RE DA 202037990s197B – reconsideration – Block: 9 Section: 33 – 18 Darke St Torrens (1,104m2)

Thank you for the opportunity to comment on this DA which seeks reconsideration of the refusal to retrospectively amend DA202037990s197B under s191 of the *Planning and Development Act 2007*. While the amending DA was refused on the grounds that it did not comply with the Multi Unit Housing Development Code (MUHDC) and the Residential Zones Development Code (RZDC), it is now clear that residence 1 is Fundamentally Non-Compliant and the reconsideration DA does not comply with the *Planning and Development Regulation 2008*, *Building Act 2004*, and the *Building (General) Regulation 2008*.

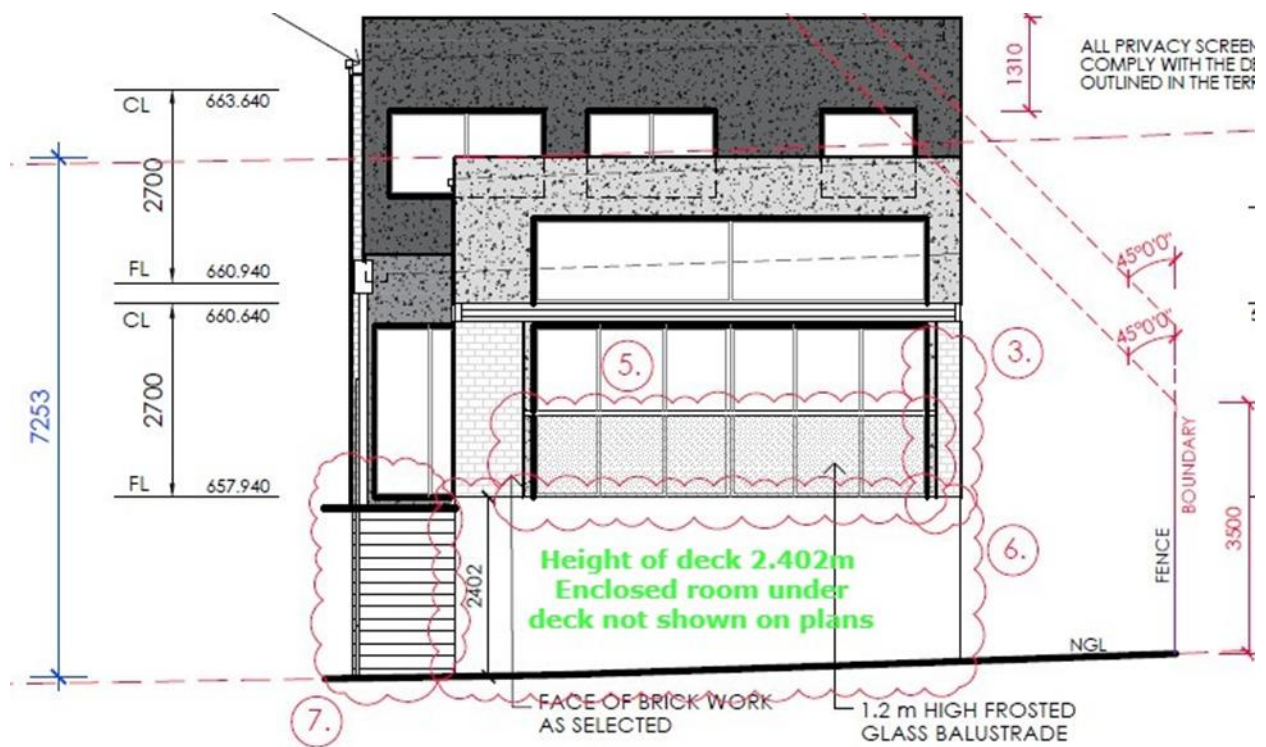
This development imposes a material detriment to the neighbours from the huge windows that facilitate overlooking and an invasion of privacy causing an adverse impact on the enjoyment of our dwellings and private open space.

Bad outcomes for the neighbours' as the huge windows 100% overlook our private open space

- The new fence is 1.8m however the unscreened windows are above this level.
- The large windows run down the side of the development.
- A retaining wall has been installed to lift the ground level by the external stairs
- The deck is not enclosed in the plans.
- Neither the deck nor the room below are included in the plot ratio.
- The deck is up to 2.4 m and is an upper storey.

The deck is 2.4m above natural ground level – the plans do not enclose the deck or state what this space will be used for

This diagram shows the contours and the non-compliant upper floor levels

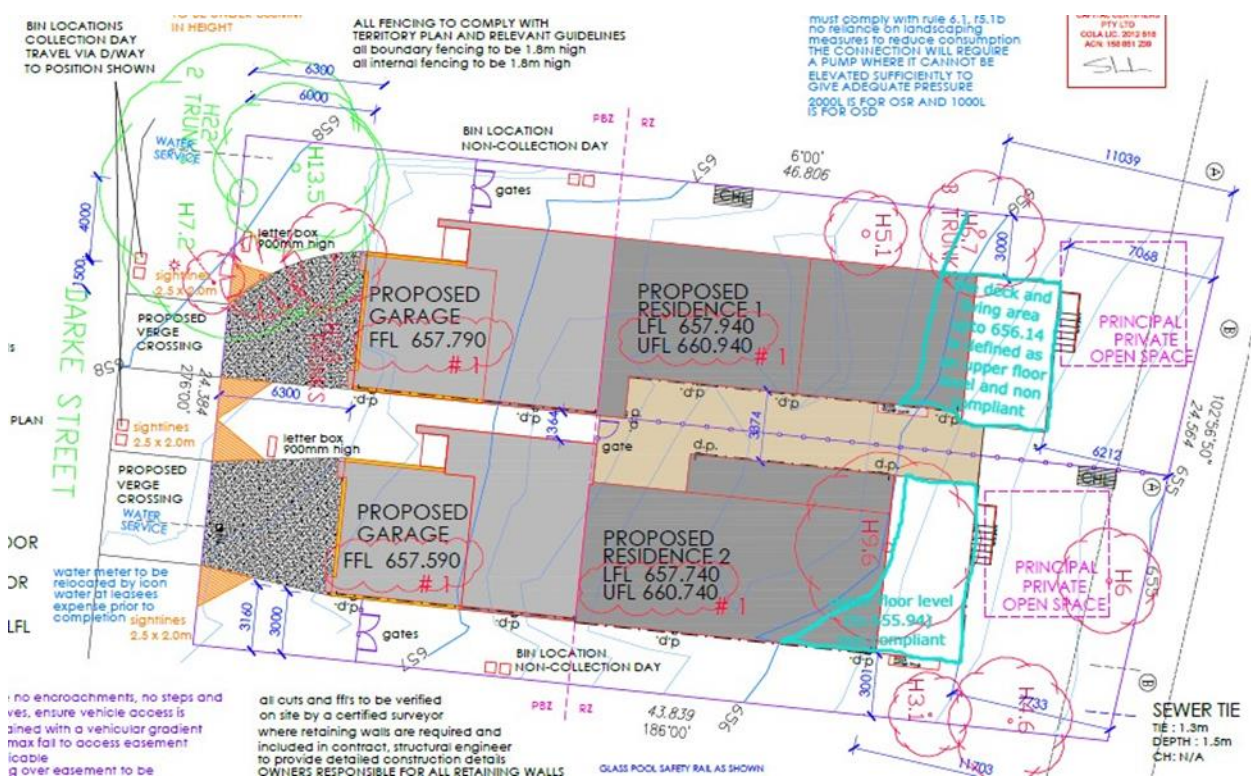
- the building is an Upper Floor Level (UFL) because the finished floor level is greater than 1.8 metres above datum ground level at any point.

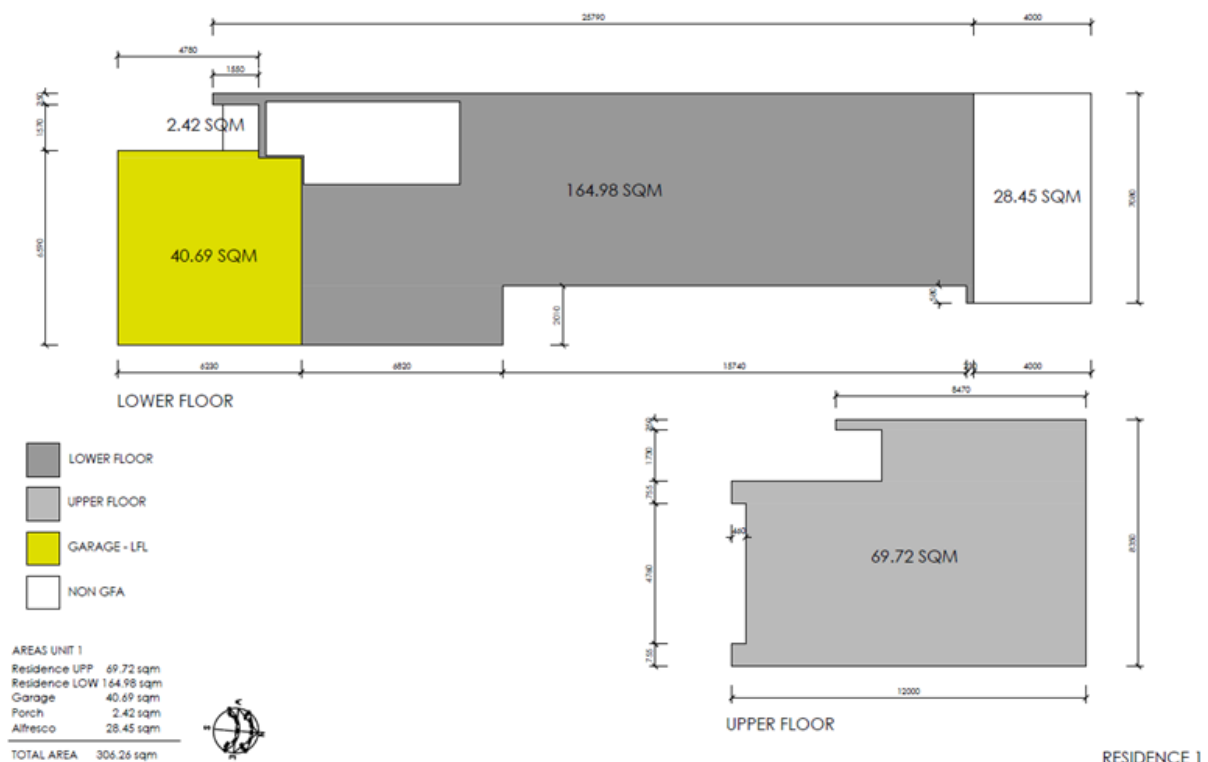
The submission claims to have a plot ratio of 49.76% however including the deck and room under the deck brings the plot ratio **to 61.1%**.

Territory Plan - MUHDC Rule 7 requires a **plot ratio of 50%**

- Residence 1 – 40.69 + 164.98 + 69.72 + 28.45 (deck) + 28.45 (room below deck) = 332.29
- Residence 2 – 40.69 + 164.14 + 69.72 + 34.03 (deck) + 34.03 (room below deck) = 342.61
- Plot Ratio = (332.29+342.61) / 1,104 = **61.1%** - **does not comply – over 50% max plot ratio**

Building envelope

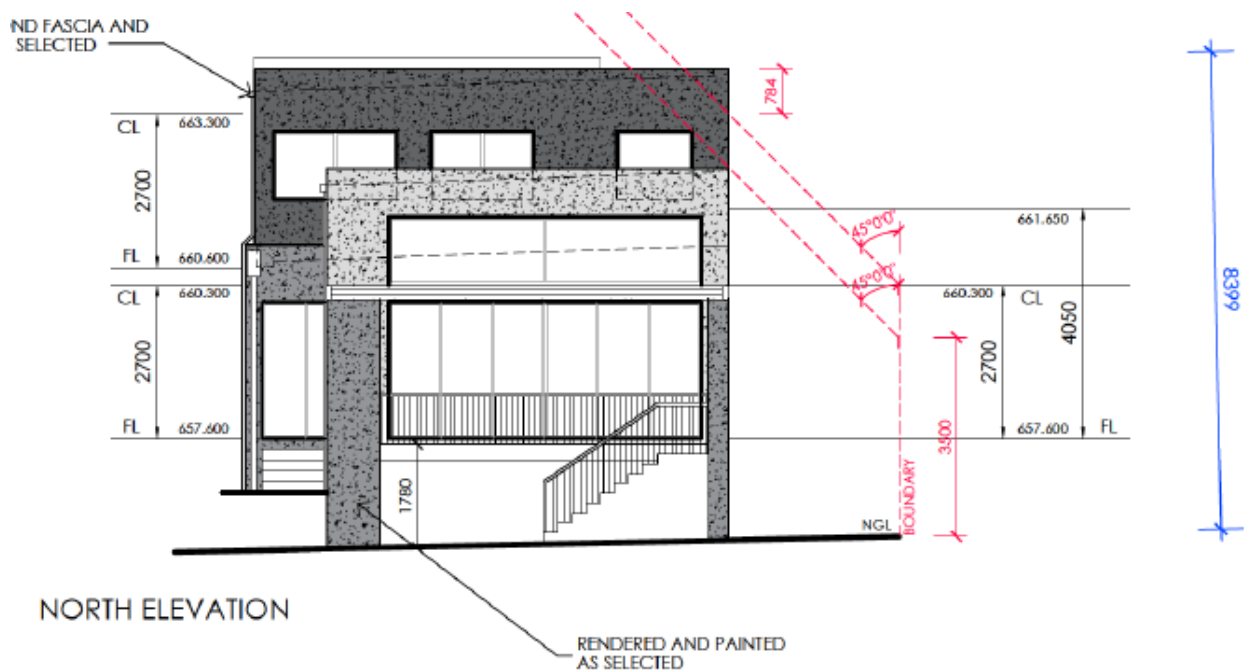
Territory Plan - MUHDC Rule 25 – **Building envelope – 45 degrees** from 3.5m fence

- The DA claims that they have utilised the 340mm tolerance allowed under the *Planning and Development Regulation 2008* however parts of the deck are over 600mm higher than the original DA.
- The increase in height increases the building envelope encroachment.

I have lost morning sun in my driveway and the car is frozen. The windows 100% overlook my property and my privacy is significantly impacted by this non-compliant design. The building does not comply with Criteria 25 because it does not achieve all of the following:

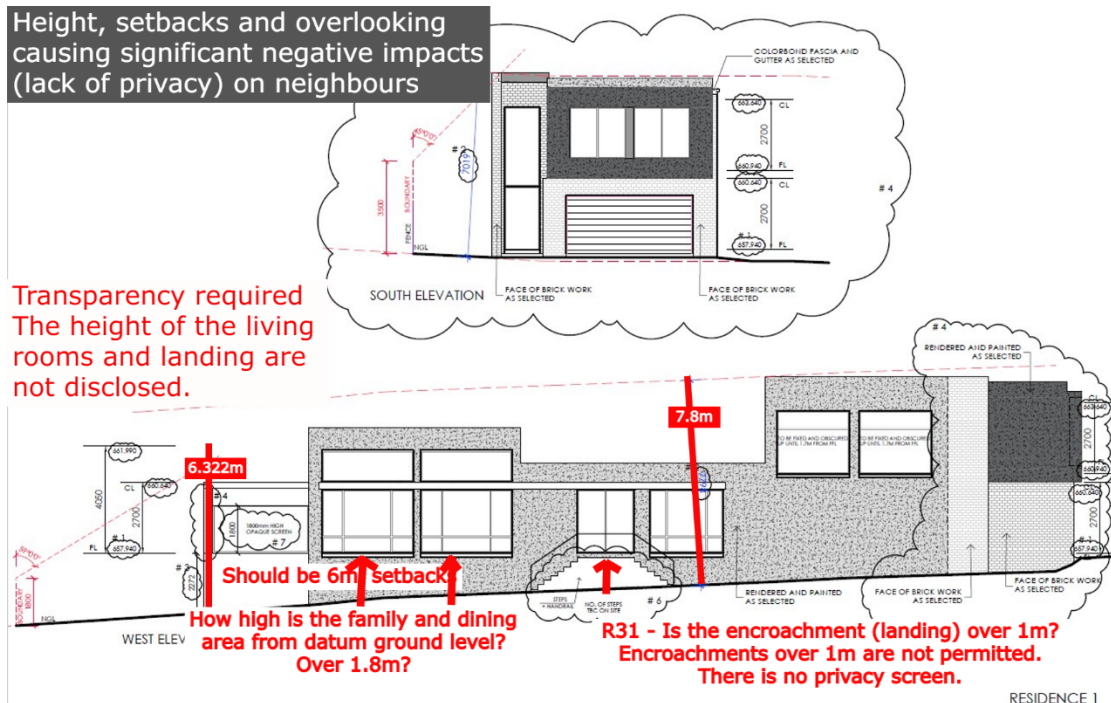
column 1 Item	column 2 element of building work	column 3 when building work is fundamentally noncompliant
2	A floor Residence 2	(b) the total floor area exceeds the total floor area shown on the approved plans that relate to the building work by more than 10% <ul style="list-style-type: none"> • The plans do not include the room under the deck (28.45m²) which is > 10% of the 3112m²
4	A room	(b) the number of rooms is more than the number shown on the approved plans that relate to the building work The rooms under the deck have the potential to be used as home theatres
6	Height of a building	(b) the vertical distance from the ground to any point on the building is more than 500mm greater than shown on the approved plans that relate to the building work Residence 1 <ul style="list-style-type: none"> • deck – 622mm difference to original plan
7	number of storeys of a building	the number of storeys is more than the number shown on the approved plans that related to the building work <ul style="list-style-type: none"> • the deck and the living room are defined as upper floors

9	useless space in a building	the approved plans that relate to the building work do not show a use for a space in the building and the space is constructed in a way that it could be reasonably used for human occupation example - Approved plans show a space between the ground and a floor above the ground (the subfloor area) but do not show a use for the subfloor area. The subfloor area is constructed in a way that it could reasonably be used as a home theatre. <ul style="list-style-type: none"> • The area below the deck has been enclosed with a door to a 2.4m ceiling that can easily be converted to a habitable room.
10	Door or window	(a) the number of external doors or windows is more than the number shown on the approved plans that relate to the building work (b) a door or window is located in an external wall even though the approved plans that relate to the building work shows no part of a door or window to be located in the wall <ul style="list-style-type: none"> • The door and room under the deck are not on the original plans

11	An enclosure	(a) a wall or roof encloses or partly encloses a building or space shown on the approved plans for the building work not to be enclosed or partly enclosed with the wall or roof; (b) a wall or roof has an area of more than 2m ² <ul style="list-style-type: none"> • The walls enclosing the area under the deck are not on the original plans
